**STAFF REPORT:** 10/12/2022 REGULAR MEETING

**APPLICATION NUMBER:** #22-8055

**ADDRESS:** 2801 OAKMAN

**SCOPE:** INSTALL VINYL WINDOWS (WORK COMPLETE WITHOUT APPROVAL), REPLACE EXISTING VINYL WINDOWS WITH NEW VINYL WINDOWS

*Site Photo 1, by staff Sept.23, 2022: (Northwest) front elevation.*

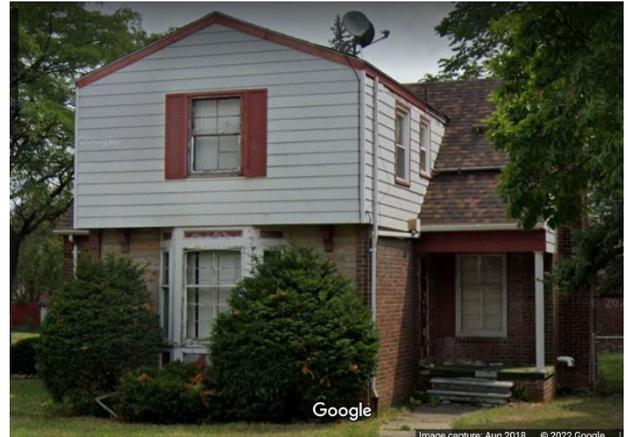
- Staff observed that besides the replacement of the original windows, other violations are present on the property since 2018, which are not included in this application, and include the following work done without approval (*see site photos 1 and 2*):

- The front elevation shutters were removed
  - The aluminum siding was painted
  - The front bay window wood paneling has been covered with vinyl siding

- The front foundation shrubs were removed and replaced with a garden bed.
- Staff has identified that the original, divided-light double-hung windows on the front elevation were distinctive character-defining features that have been removed without approval, and therefore substantially detracts from and destroys the historic appearance of the building.

Site Photo 3, by staff September 23, 2022: (Southeast) side/rear elevation showing existing vinyl windows.

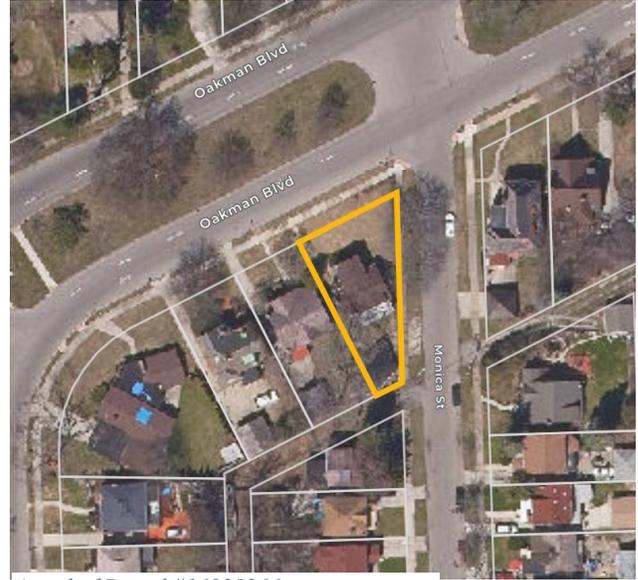
- Staff observed that the installed vinyl windows have several features that are not appropriate:
  - the surrounding coil covering the brickmold is large and gives the windows a chunky appearance

- the between the glass grids give the windows a flat appearance, losing the dimensions of the historic muntins
  - the configuration of the installed windows does not match the original configuration

- the dimensions of the header and base of the window do not match the original wood windows.
- It is staff's opinion that the proposed window vinyl replacements have the same inappropriate features as those listed above.
